Meeting Agenda Plat Committee

Monday, February 27, 2023

1. Barber Subdivision; KPB File 2023-013

PENINSULA SURVEYING, LLC 10535 KATRINA BOULEVARD, NINILCHIK, AK 99639 (907)306-7065	
PLAT OF BARBER SUBDIVISION	
A SUBDIVISION OF NW1/4 NE1/4 SEC. 8, T54N, R10W, S4M, KENAI RECORDING DISTRICT, KENAI PENINSULA BOROUGH CONTAINING 40.000 ACRES	
OWNER: MATT BARBER 20777 S 64TH CT, HICKMAN, NE 68372	
SCALE: 1" = 100'	DATE: JANUARY 30, 2023
DRAWN: JLS	SHEET: 1 OF 1

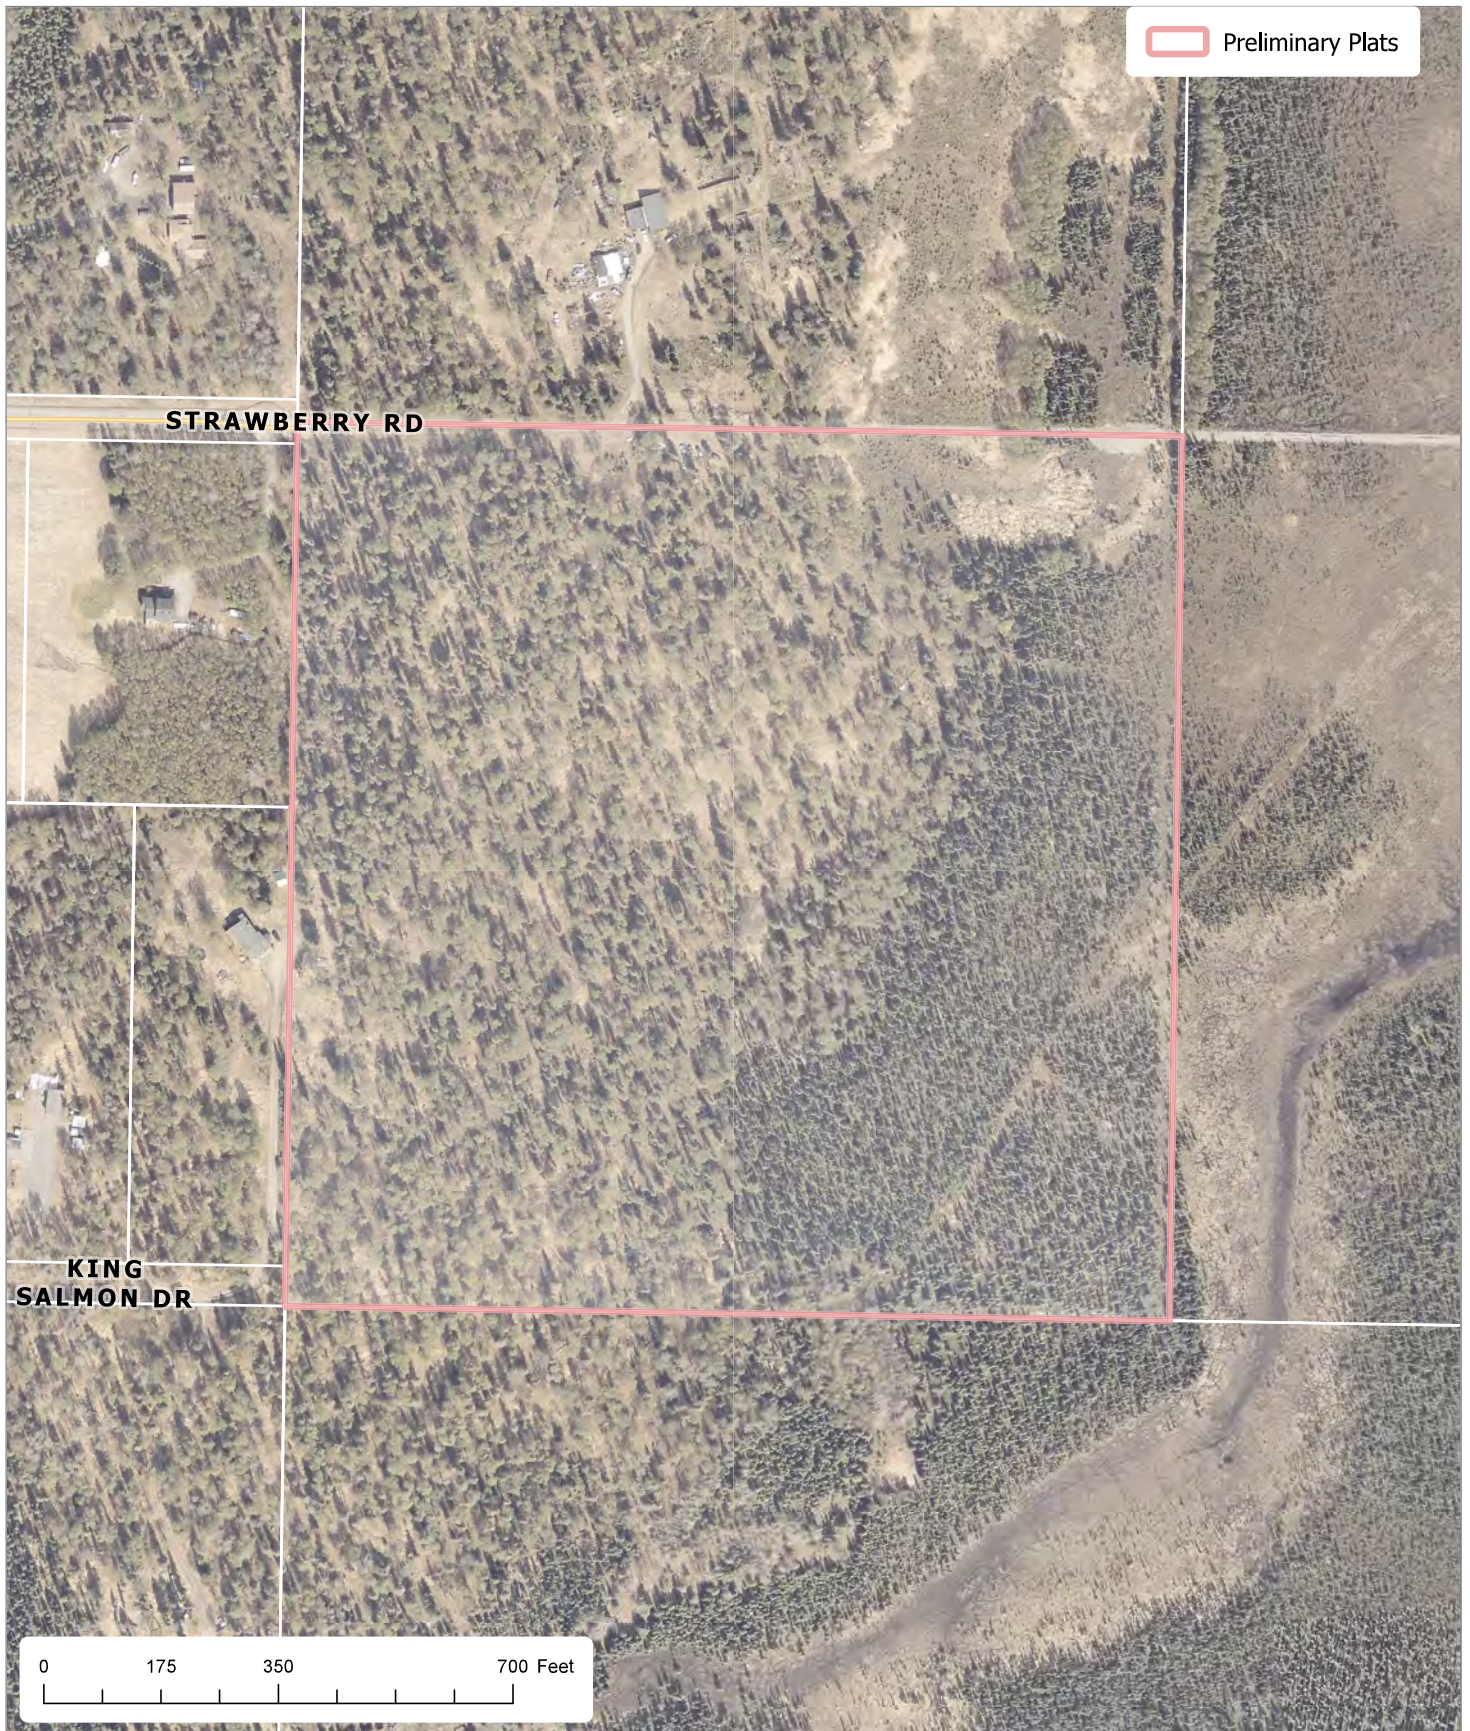
This plat is proposing to dedicate a 30 foot width for Strawberry Road atop an existing 33 foot section line easement. It appears to be cleared and used for access for the lot to the north as well as a large acreage lot to the east with improvements present. The northern portion of Strawberry Road appears to be subject to a 33 foot section line easement to provide additional width. If the owner to the north ever subdivides a matching dedication can be obtained. The western portion of Strawberry Road appears to contain some steep slopes. ***Staff recommends proof that the slopes comply with code or submittal of centerline profiles and cross-sections be submitted for review to determine if additional width or easements are required.***

A 60 foot wide right-of-way is proposed to provide a connection between Strawberry Road and King Salmon Drive within the middle of the subdivision. This location avoids a dedication through the designated wetlands. All proposed rights-of-way dedication will fall under borough jurisdiction as the City of Kenai limits ends along the western boundary.

The block length is not compliant. There are many large acreage lots within this area. The new dedication will improve the eastern block but it will still exceed allowable limits. The new dedications will help provide a closed block to the west. The plat is proposing to dedicate the right-of-way in the middle of the subdivision instead of along the western and eastern boundary to avoid some terrain issues. Lot 18 is a large acreage lot with designated

- Staff recommendation:** *Provide section line easement designations to the east of the subdivision. The City of Kenai limits are located along the western boundary. Provide a depiction and label.*

- Staff recommendation:** *Provide a Township label.*
- L. Contours at suitable intervals when any roads are to be dedicated unless the planning director or commission finds evidence that road grades will not exceed 6 percent on arterial streets, and 10 percent on other streets;

Staff recommendation: *Provide documentation that the slopes comply with code or provide centerline profiles and cross-sections for Strawberry Road for review to determine if additional right-of-way width or easements are required.*

Staff recommendation: *Add the plat note: No structures are permitted within the panhandle portion of the flag lots.*

KPB 2023-012

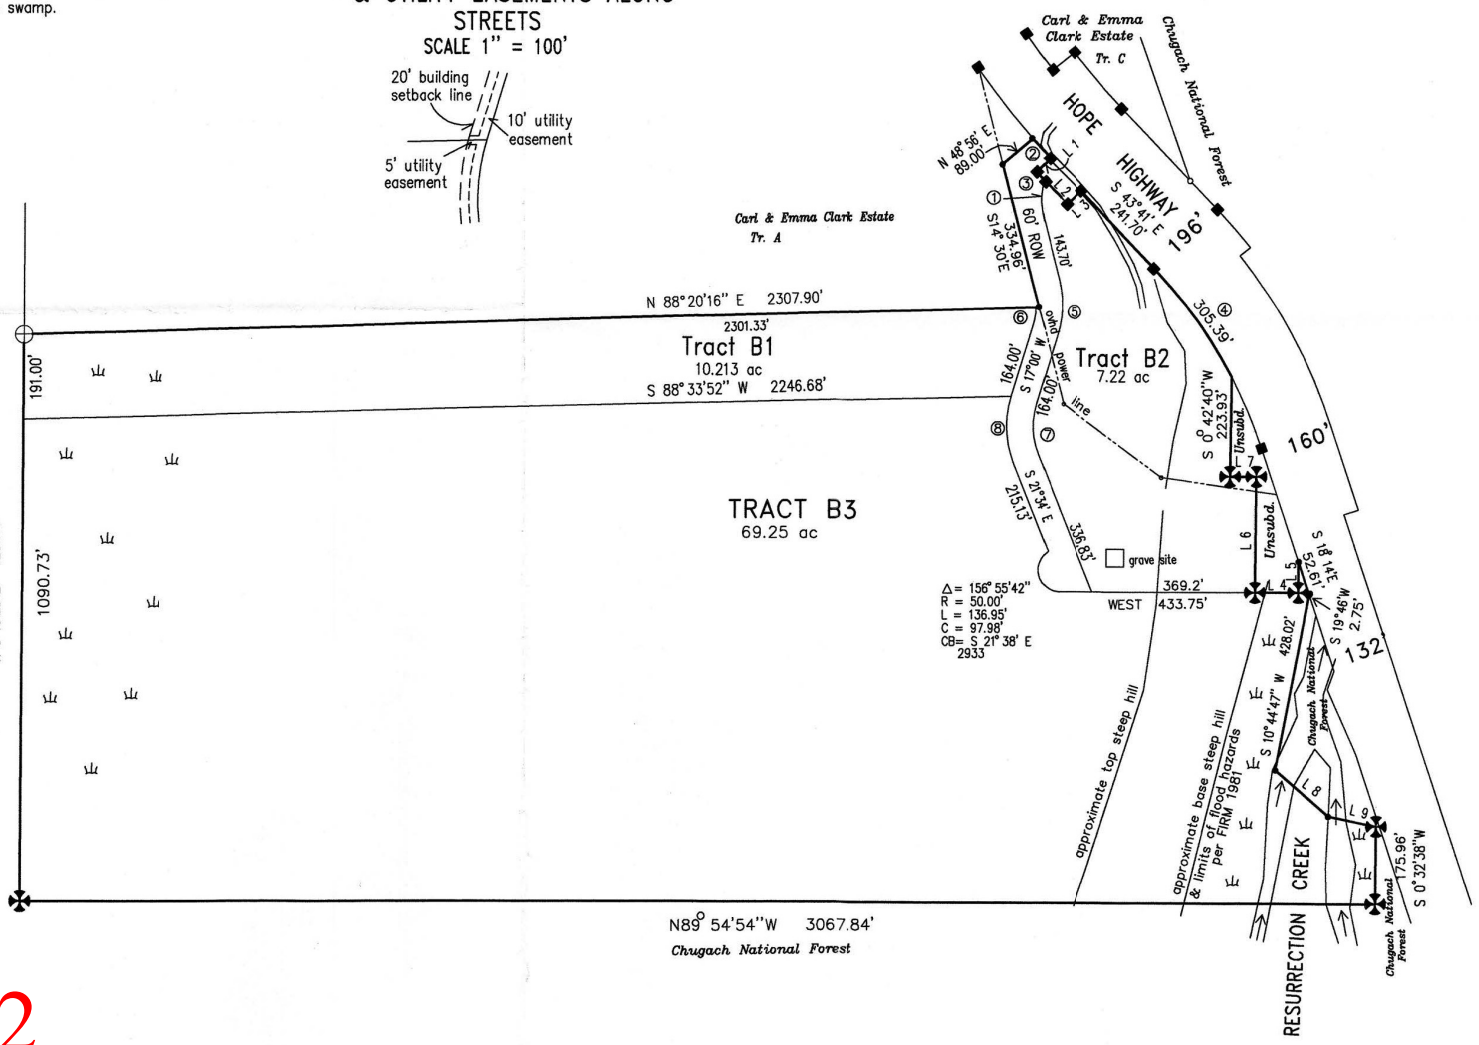
Location and Legal Access (existing and proposed): The preliminary subdivision is located in the Hope area and is near mile 17 of state maintained Hope Highway. There is currently a driveway constructed from the Hope Highway onto the parent property. The access will remain within Tract B2 to provide access to the improvements present. A new right-of-way dedication is proposed that will access the Hope Highway. This dedication is proposed to be inline with the current driveway entrance to the highway. The driveway will then meander southeast within Tract B2. The dedication will be along the southwestern area. The dedication will provide access all three tracts.

There appears to be some discrepancy on the boundary of the subdivision to the section lines. A Record of Survey was done and recorded, SW 2008-03. Per that record of survey, a portion of Tract B is within the southeast portion of Section 29. ***Staff recommends the surveyor verify the location of the section corner and depict the location in relation to the subdivision, amend the location description in the title block, and update the depiction within the vicinity map.***

KPB Roads Dept. comments	Out of Jurisdiction: No Roads Director: Griebel, Scott Comments: No comments
SOA DOT comments	No comment made. It was noted however from ROW map FH-14-1(1) sheet 4 of 5, the ROW labeled as 160' should be 166'

Proposed Tract B2 will contain multiple improvements. **Staff recommends the surveyor verify no encroachments will be created by the placement of the lot line.** A private grave site is present within proposed Tract B2. If this is the site referenced within an easement located within a deed, **staff recommends the depiction remain with a reference to a plat note with the easement information.**

Resurrection Creek runs adjacent and within the southwestern portion of the subdivision. A plat note is present on the plat regarding the Anadromous Waters but should be revised to match code.

There is a recorded easement for the benefit of Chugach Electric Association, Inc. The easement does not have a disclosed location. **Staff recommends a plat note be added for the easement.**

Platting Staff Comments: A soils report is not required due to the size of the lots. Correct the typo within the note.

Surveyor Segesser Surveys 30485 Rosland St Solcota, AK 99609 (907) 262-3909	Owner David R. Parker & Queen Aleta Parker P.O. Box 1462 Sterling, AK 99572
JOB NO. 22370	DRAWN 2-1-23
SURVEYED DEC, 2022	SCALE: 1"=100'
FELD BOOK: 22-7	SHEET: 1 of 1

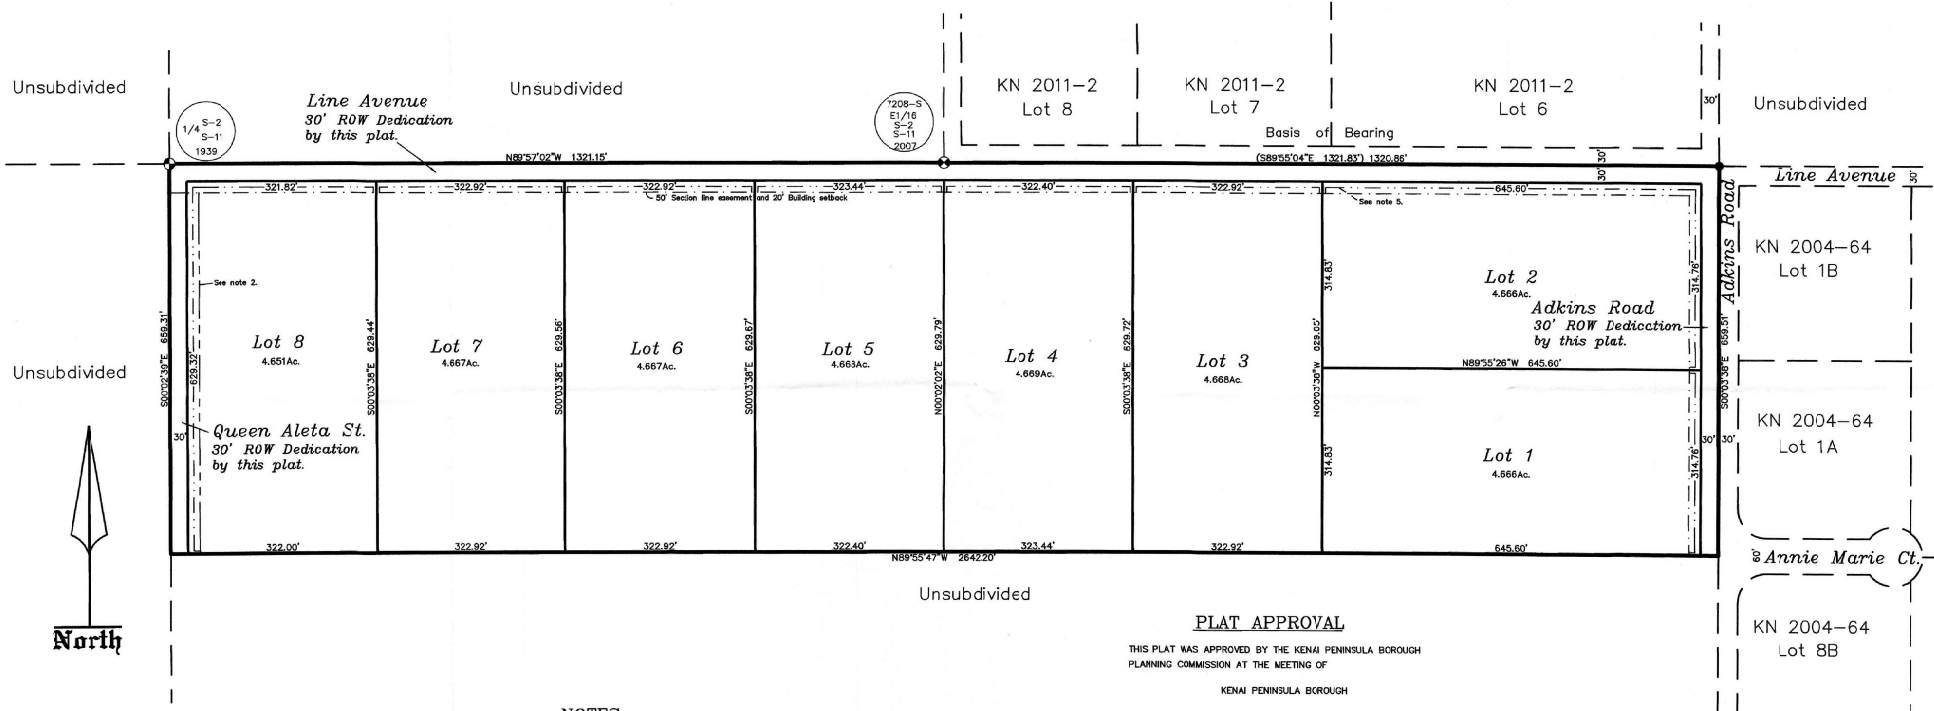
Along the western portion of the subdivision there does appear to be some steep slopes present. Some of these steep slopes appear to be within the proposed right-of-way dedications. **Staff recommends centerline profiles and cross-sections be provided for Line Avenue and Queen Aleta Street to determine if additional right-of-way widths or easements are needed. Show the centerline of Line Avenue on the plat drawing.**

South of the subdivision is a lot matching the size of this subdivision. This lot is 40 acres in size and owned by Alaska Pipeline Company. Per KPB GIS Imagery, there is an airstrip present along the northern portion of the lot and it is close to the southern boundary of the proposed plat. Imagery does not indicate any encroachments. **Staff recommends the surveyor verify during the field survey that there are no issues with the location of the airstrip.**

HEA has request the transmission line north of the property be located to verify if any of the 100 foot wide easement per ADL 38269 affects this property and I so to show on the plat. And to add the following plat note:

- C. The location, width, and name of existing or platted streets and public ways, railroad rights-of-way, and other important features such as section lines or political subdivisions or municipal corporation boundaries abutting the subdivision;
Staff recommendation: *Some road depiction and section line easements will need to be updated before final based on preliminary approved plats in the area. The width of Line Avenue east of Adkins Road needs to be updated as does the eastern half of Adkins Road. Provide a label and width for Coronet Street. If the dedication to the north has not been recorded prior to final, show the section line easement, and show the section line easement along Adkins Road south of the subdivision.*

- F. The location, width and name of existing and platted streets and public ways, railroad rights-of-way, easements, and travel ways existing and proposed, within the subdivision;
Staff recommendation: *Name of Queen Aleta Street may need to be revised.*

- 20.30.160. Streets-Name requirements. Streets shall be named to conform to KPB Chapter 14.10
Staff recommendation: *Aleta Avenue is located to the north of this subdivision. It is advised to remove Aleta from the name and staff recommends "Queen Street".*

Correct plate note 4 by adding the reference to KPB Code 14.06.

JCB NO.	23006	DRAWN:	1-17-23
SURVEYED:	N/A	SCALE:	1"=100'
FIELD BOOK:	N/A	SHEET:	1 of 1

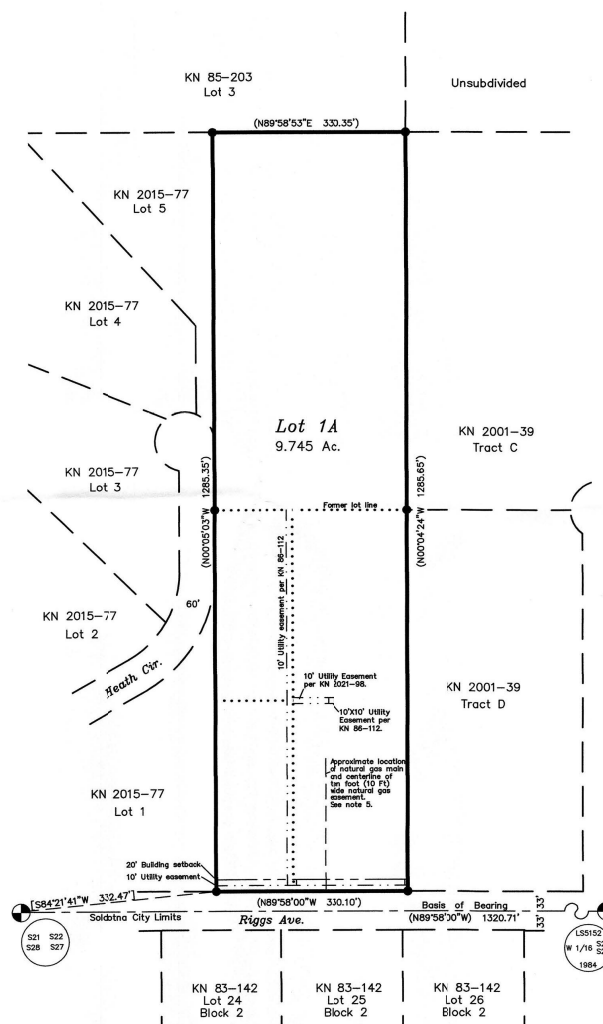
The block is not compliant. There are several dedications in the area but many are cul-de-sacs and do not provide through dedications to provide for closed and compliant block lengths. Mackey Lake Road, Riggs Avenue, a portion of Heath Circle, section line easements, Brenda Way and Delcie Drive define the current block. There are low wet areas to the west of the subdivision and with the current development in the area it will be difficult to continue any road dedications through to improve the block. The parent subdivision, S & S Subdivision Young Replat, received an exception to KPB 20.30.170 block length at the October 25, 2021 Plat Committee meeting. **Staff recommends the plat committee concur that an exception is not required as new dedications will not improve the overall block.**

Site Investigation: The terrain is relatively flat within the subdivision boundary. There does appear to be some low wet areas within the northwest corner of the subdivision that have been designated as Kettle. **Staff recommends the low wet areas be added to the final plat and a wetland determination plat note be added.**

- D. A vicinity map, drawn to scale showing location of proposed subdivision, north arrow if different from plat orientation, township and range, section lines, roads, political boundaries, and prominent natural and manmade features, such as shorelines or streams;
Staff recommendation: Provide a label for Soldotna Creek.
- H. Approximate locations of low wet areas, areas subject to inundation, areas subject to flooding or storm water overflow, and the line of ordinary high water. This information may be provided on an additional sheet if showing these areas causes the preliminary plat to appear cluttered and/or difficult to read;
Staff recommendation: Area within northwest corner should be depicted as wetlands.
